## FAQ Log April 2017

## FAQ 16-04, Browns Ferry Safety System Functional Failure (Draft NRC Response)

FAQ 17-02  
Palo Verde Unit 3 Scram

## FAQ 17-03 Baseline Unavailability Critical Hours

Figure 1: Reactor Power during the Event

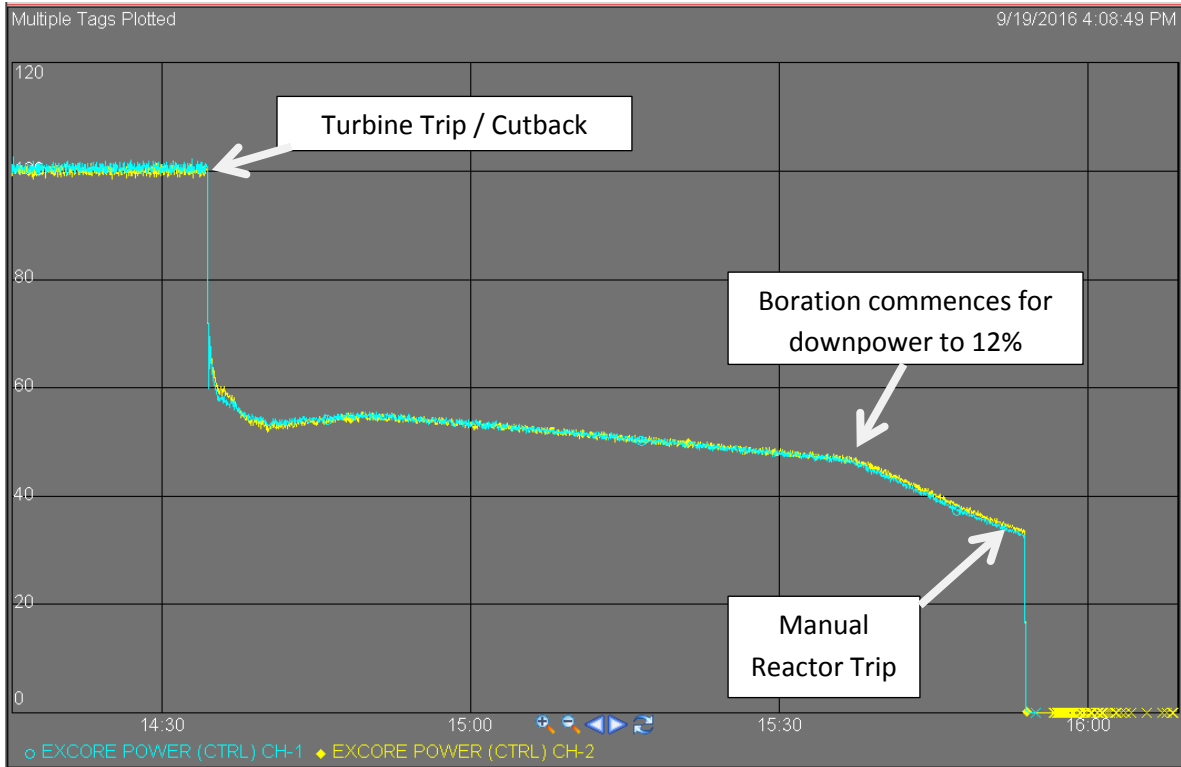
On September 19, 2016, the PVNGS Unit 3 main turbine tripped at 1434 with the unit operating at 100% power. A reactor power cutback occurred automatically, as designed. The control room staff began a power reduction to 12% using abnormal operating procedure 40AO-9ZZ08, “Load Rejection.” Subsequently, based on an assessment of need for troubleshooting and repairs, potential reactivity management challenges at the end of core life, and the uncertainty of cause which might delay the return to full power, the control room staff and plant management made a decision to complete a plant shutdown and place the plant in Mode 3 by tripping the reactor using step 3.24 of 40AO-9ZZ08 from approximately 34% power at 1554 to facilitate repairs. No additional, unexpected plant conditions were occurring that would require a plant shutdown other than the loss of the main turbine. Refer to the Figure 1 for a graphical display of the power changes during the event.

Tripping the reactor from 34% power was a permissible step of the abnormal operating procedure to establish plant conditions to perform troubleshooting and conduct repairs. The abnormal operating procedure provides the option of either plant shutdown or holding power at 12% while conducting repairs following a load rejection event. Stabilizing at 12% power at the end of core life presents challenges to the operators that are not warranted for an extended period of operation. However, the reactor protection system was not challenged and plant conditions did not require a reactor scram. The plant was not approaching reactor scram setpoints, and conditions were not likely to result in a scram. The control room staff was provided with a reactor engineering game plan that indicated the plant would be capable of reducing reactor power to 12% and stabilizing there. PVNGS management decided to shutdown the reactor and perform repairs in Mode 3 because the cause of the turbine trip was unknown and placing the plant in Mode 3 was preferred to sustaining 12% power operations for an extended period of time at the end of core life. The control room staff demonstrated conservative decision making with this course of action.

The NEI 99-02 example is dissimilar from the September 19<sup>th</sup>, 2016, Unit 3 main turbine trip. The manual scram to complete the shutdown of the plant in order to troubleshoot and repair the cause of the main turbine trip was directly related to the cause of the main turbine trip itself and not to some other unrelated failure or degrading condition in the plant. No additional, unexpected plant conditions were occurring that would require a plant shutdown. The ultimate causal linkage of the unplanned power change (turbine trip) ending in a manual scram to correct the cause of the initiating turbine trip should count only as an unplanned scram as described in the referenced NEI guidance.

The main turbine trip that ended in a manual scram should count only as an unplanned scram.
